Amendments to the Drawings:

Attachments: Replacement Sheet For Figures 2 and 9

Annotated Sheet Showing Changes For Figures 2 and 9

FIG. 2

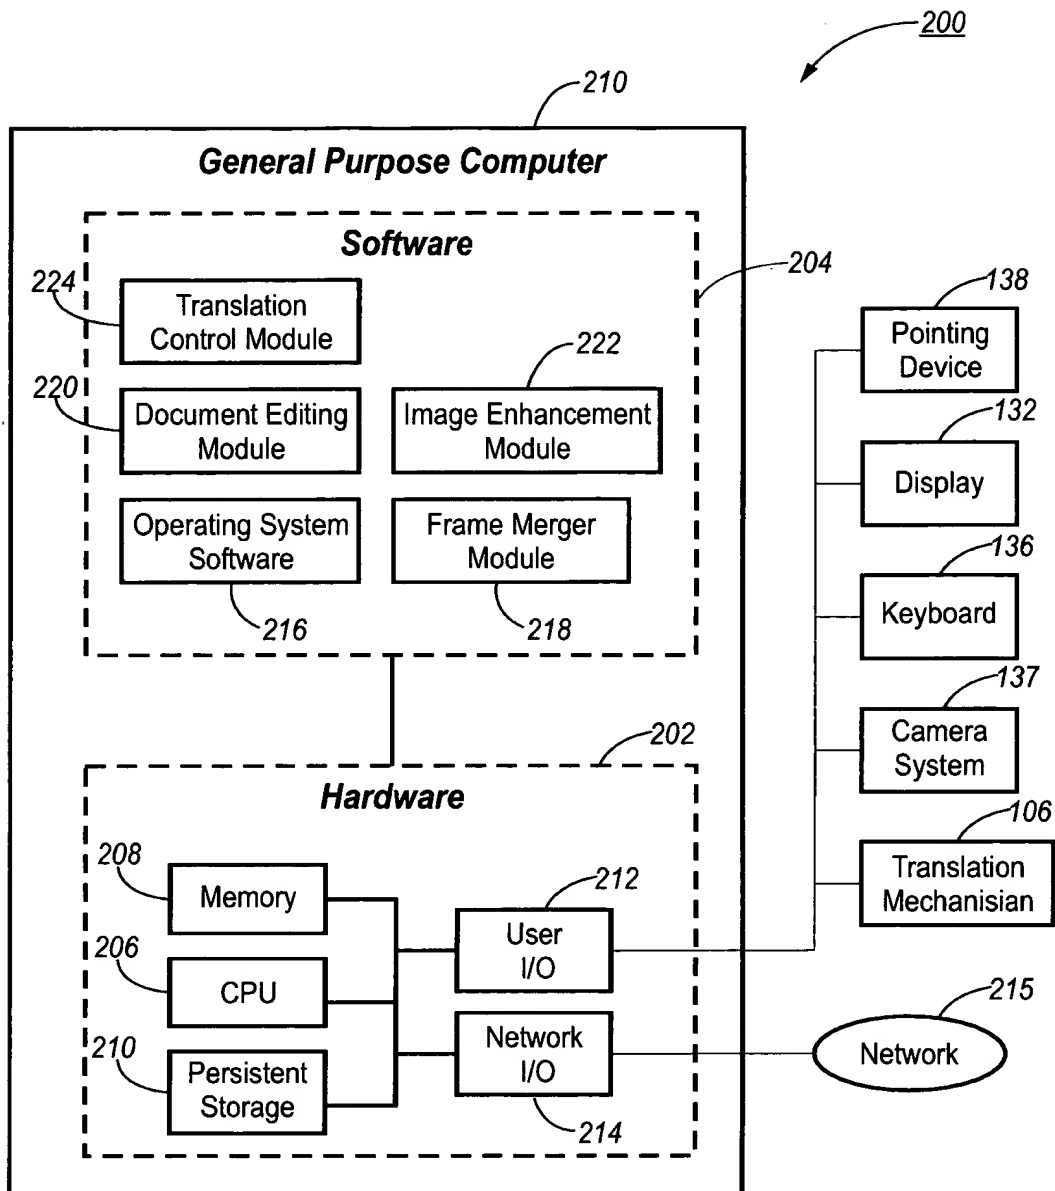
FIGURE 2: The attached sheet of drawings includes changes to Figure 2. This sheet replaces the original sheet. In Figure 2, omitted element 202 has been added and duplicate element 137 ("Pointing Device") has been renumbered as element 138. These changes are identified in the Annotated Sheet Showing Changes for Figure 2 also attached.

FIG. 9

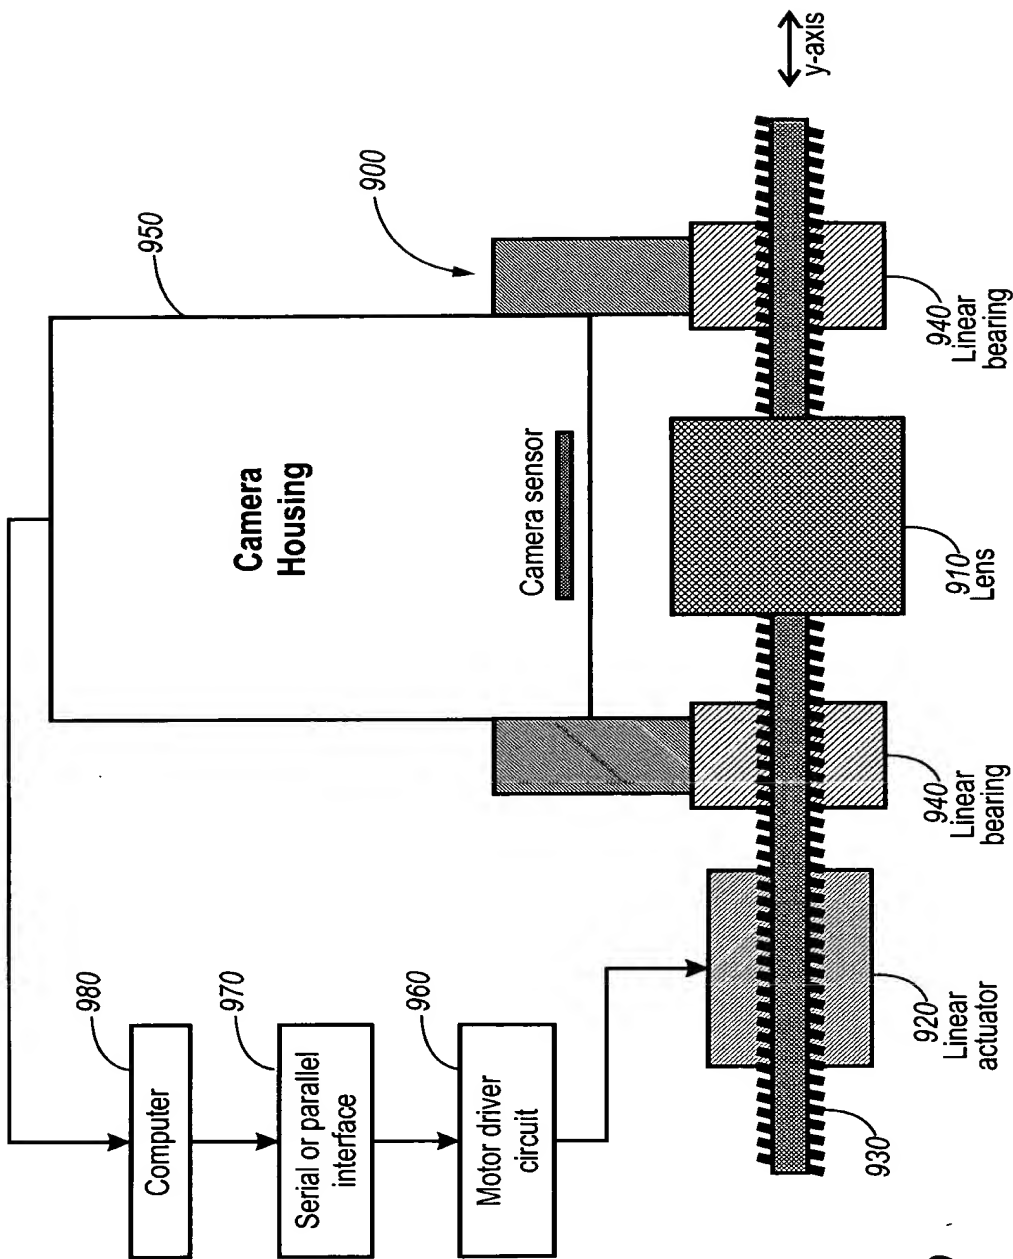
FIGURE 9: The attached sheet of drawings includes changes to Figure 9. This sheet replaces the original sheet. In Figure 9, element 990 has been removed for not being referred to in the specification, and textual references to elements 910, 920, and 940 that were present in the informal drawings filed with the Application but erroneously omitted during preparation of formal drawings have been added. These changes are identified in the Annotated Sheet Showing Changes for Figure 9 also attached.
